Your Ref
AL/40/18/PL
Our Ref
PLAN-022702
Date
17/05/2018

Proposal: 2 No. semi-detached bungalows with associated parking & landscape
Site: Land Adjacent to 14 St Johns Close, Westergate, PO20 3TH.
AL/40/18/PL

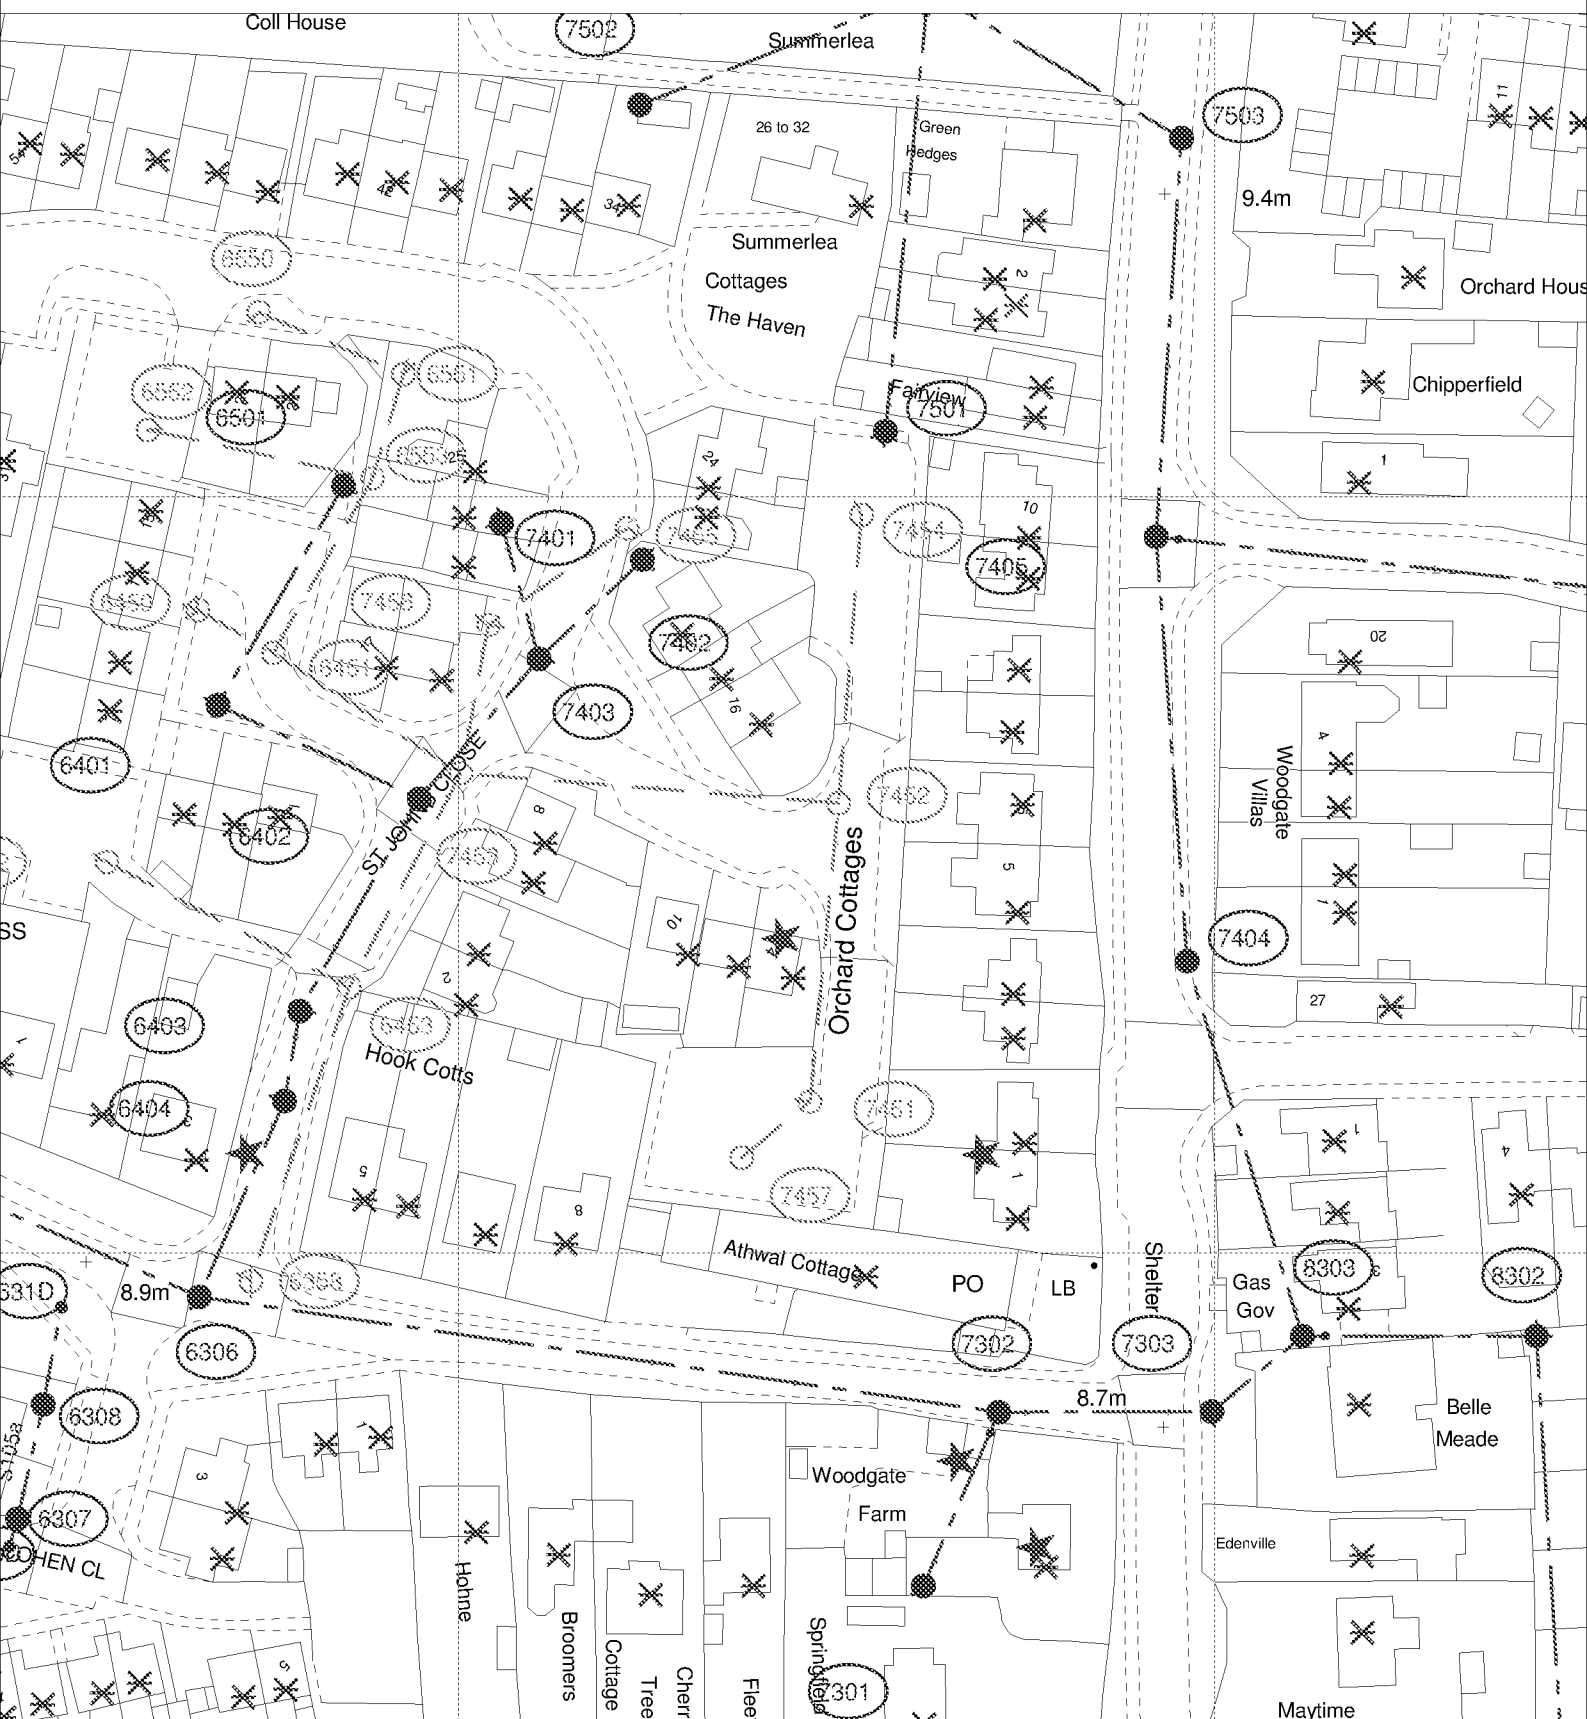
Please find attached a plan of the sewer records showing the approximate position of surface water sewer crossing the site. The exact position of the surface water sewers must be determined on site by the applicant before the layout of the proposed development is finalised.

1. The 150 mm diameter sewer requires a clearance of 3 metres either side of the sewer to protect it from construction works and allow for future access for maintenance.
2. No development or new tree planting should be located within 3 metres either side of the external edge of the public sewer
3. No new soakaways should be located within 5 metres of a public sewer.
